**RE: Suazo Residence Lot 8 Block 10 Unit 22 Volcano Cliffs  
6511 Petirrojo NW  
Grading and Drainage Plan  
Engineers Stamp Date 1/20/16 (D10D0003P8)**

## DRAINAGE AND TRANSPORTATION INFORMATION SHEET (REV 09/2015)

**RE: Suazo Residence Lot 8 Block 10 Unit 22 Volcano Cliffs  
6511 Petirrojo NW  
Grading and Drainage Plan  
Engineers Stamp Date 1/15/16 (D10D0003P8)**

ENGINEER'S SEAL  1/20/16 1/15/16 DAVID SOULE P.E. #14522	LOT 8, BLOCK 10, UNIT 18 VOLCANO CLIFFS SUBDIVISION  GRADING AND DRAINAGE PLAN   <i>Rio Grande Engineering</i> 1606 CENTRAL AVENUE SE SUITE 201 ALBUQUERQUE, NM 87106 (505) 872-0999	DRAWN BY JDG  DATE 01-14-2015
		SHEET # 1 OF 1  JOB #

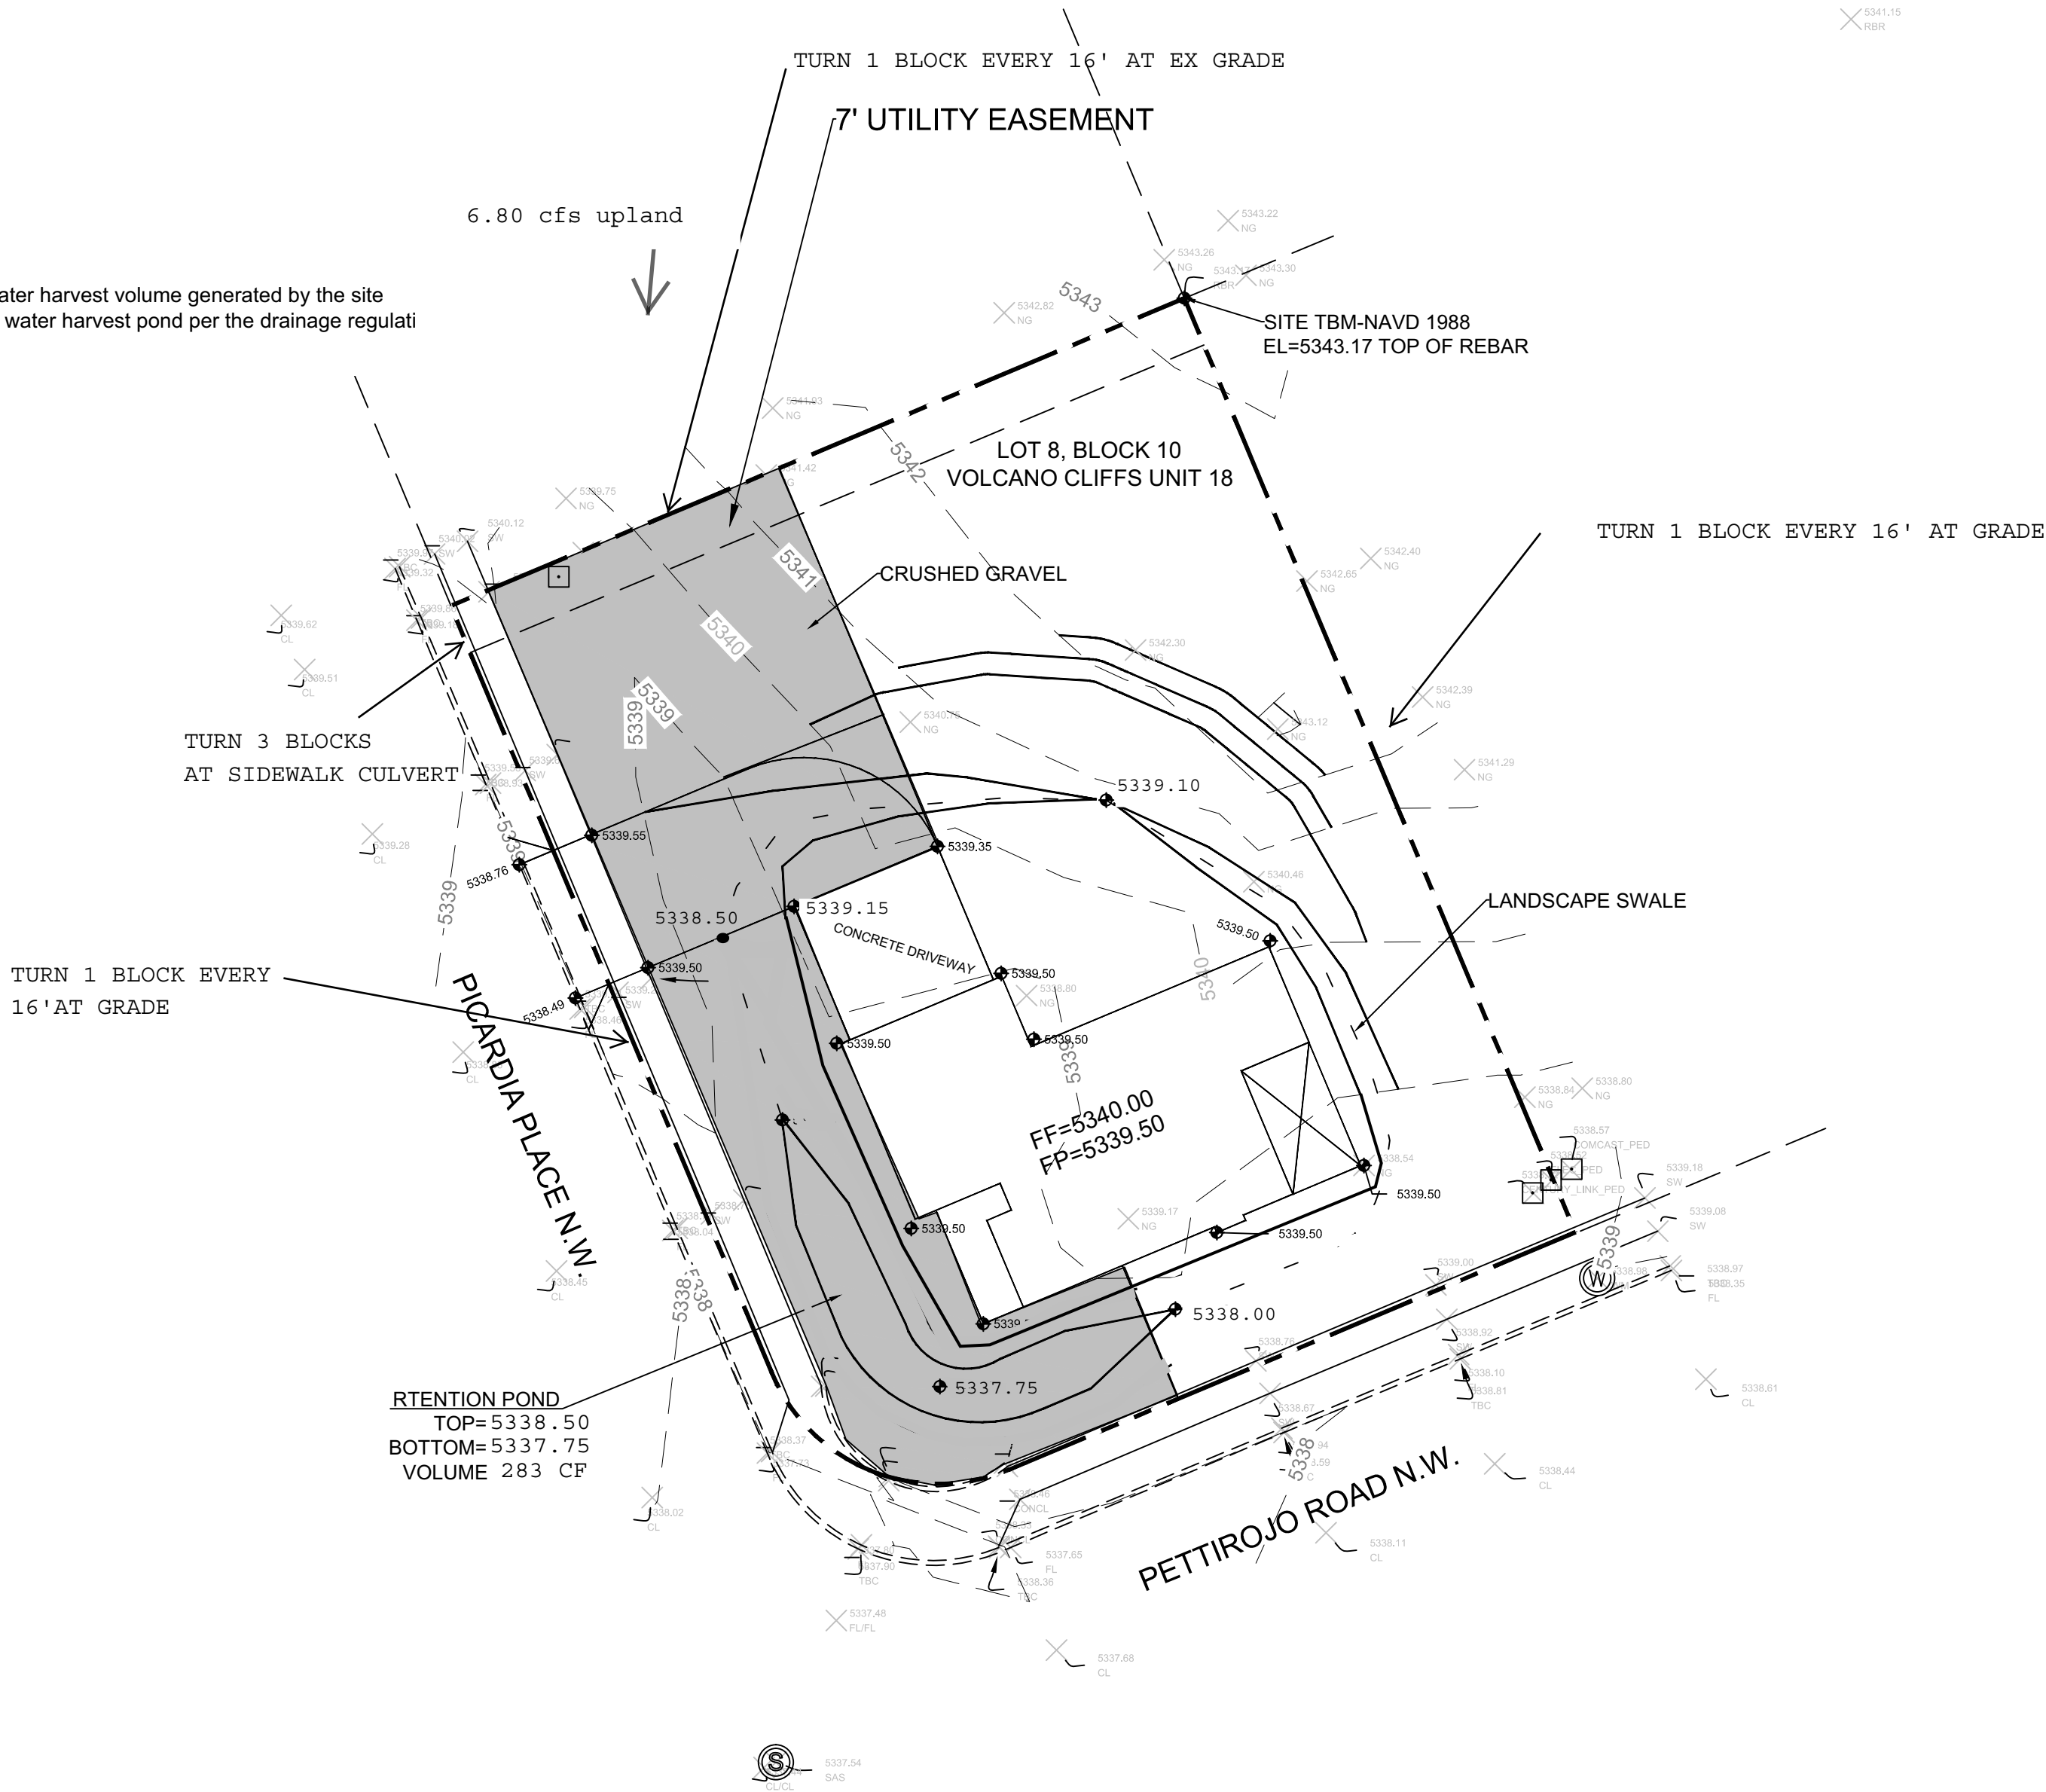
- Provide turn blocks in the east and west rear yard walls to allow flows to pass through and into the double sidewalk culvert in Picardia Place.

**ADDED NOTE TO TURN BLOCK**
